REVISED RESPONSE TO REQUEST FOR ADDITIONAL INFORMATION

APR1400 Design Certification

Docket No. 52-046

RAI No.: 154-8064
SRP Section: 16 - Technical Specification
Application Section: 16 - Technical Specification
Date of RAI Issue: 08/17/2015

Figure 1 CPC Functional Block Diagram

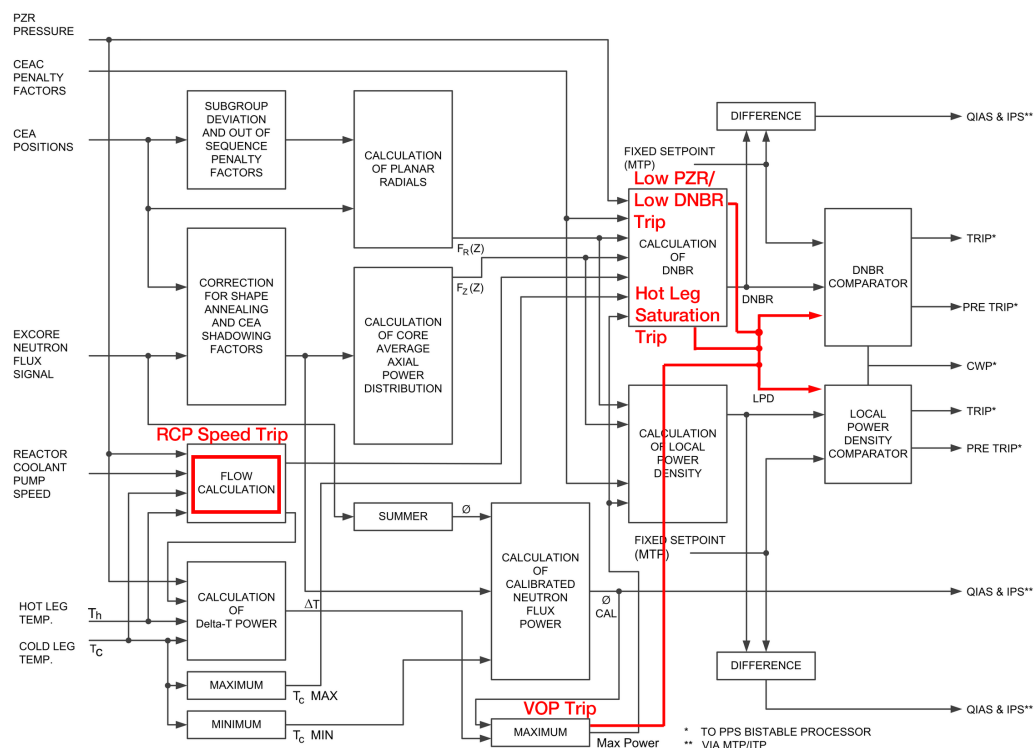
As shown in the Figure 1 from DCD Tier 2 Figure 7.2-7, the CPC auxiliary trips credited by safety analysis are described additionally with red lines.

The auxiliary trips in CPC processor are calculated using the same inputs/outputs and logics with DNBR and LPD trips. Auxiliary trip functions are only software related functions based on the DNBR and LPD measurement channels. All software in the CPC processor is monitored with software cyclic redundancy check. There is no aging and functional degradation issues in the software itself.

To provide more detail requirements, the note (d) in the attachment 2 will be added in the Surveillance Requirement for functions 14 and 15 in TS Table 3.3.1-1 and auxiliary trip parameters in the attachment 2 will be added in the Applicable Safety Analyses for functions 14 and 15 in the BASES. Surveillance Requirement 3.3.1.10 is for the CPC auxiliary trip.
